PROJECT PHASE
**PERMIT
REVISION**

PROJECT TITLE
**THE
OGUNMEFUN
RESIDENCE**

Amendment, Permit # B19004373

add bathroom to fully finished basement addition,
a change screen porch to enclosed 3 seasons room, and
add bathtub to master bath. This will be the 2nd
permit amendment that we have submitted.

SITE PLAN

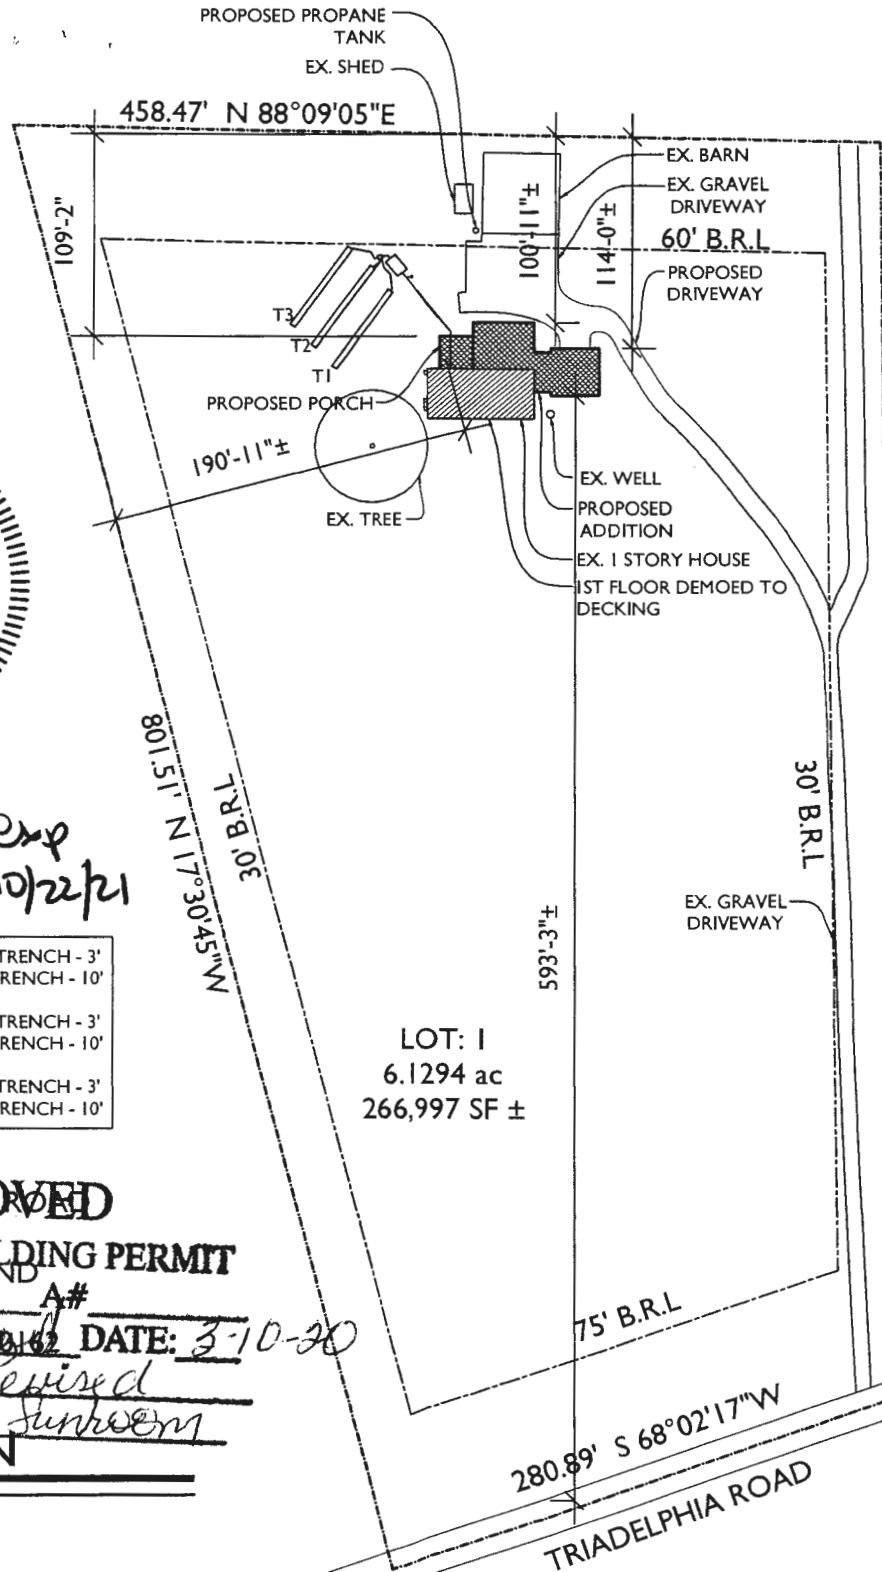
Comments: Revised lot plan to convert screen porch to sun room addition

DESC OF WORK: Revised plan for sun room
